# Access Compliance Report

## Public Rights-of-Way

### (Curb Ramps)

Intersection ID: 17795	Main Street: CONNECTING_RD	Cross Street: E WOODLAWN RD	Location: NW
ADA ID: E6CDF28D07BA	Ramp Type: ParaDiag	Initial Pass/Fail: Fail	Overall Compliance: No
			Severity Score: 26.25

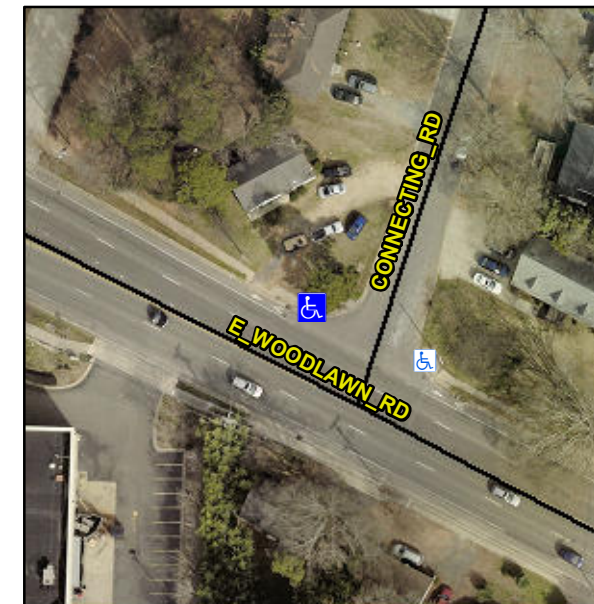
**LT RP < 5%**

**R304.3.2, R304.5.3**

Compliance	Description	Data	Compliance	Description	Data
N/A	Ramp Length LT (in)	57.0	N/A	Ramp Length RT (in)	41.0
Yes	Ramp Width LT (in)	84.0	Yes	Ramp Width RT (in)	84.0
Yes	Ramp Slope LT (%)	2.4	No	Ramp Slope RT (%)	15.5
Yes	Ramp XSlope LT (%)	1.8	No	Ramp XSlope RT (%)	3.9
N/A	Landing Length (in)	N/A	N/A	DWS Provided?	N/A
N/A	Landing Width (in)	N/A	N/A	DWS Contrast?	N/A
N/A	Landing Slope (%)	N/A	N/A	DWS Length (in)	N/A
N/A	Landing X Slope (%)	N/A	N/A	DWS Full Width?	N/A
N/A	Landing Curb? (Y/N)	N/A	N/A	DWS Offset (in)	N/A
N/A	Shared Landing?	N/A			
N/A	Gutter Ponding?	N/A	N/A	Gutter Slope (%)	N/A
N/A	Gutter Lip Ht (in)	1.0	N/A	Gutter X Slope (%)	N/A
N/A	Painted X Walk1?	No	N/A	Painted X Walk2?	No
	X Walk 1 Direction	To SW		X Walk 2 Direction	To SE
N/A	X Walk 1 Width (in)	N/A	N/A	X Walk 2 Width (in)	N/A
	X Walk 1 Slope (%)	0.5		X Walk 2 Slope (%)	1.9
	X Walk 1 X Slope (%)	2.7		X Walk 2 X Slope (%)	5.3
N/A	Ramp inside XWalk1?	N/A	N/A	Ramp inside XWalk2?	N/A

**Remove & Replace Curb Ramp With Two New Directional Ramps or Equivalent.**
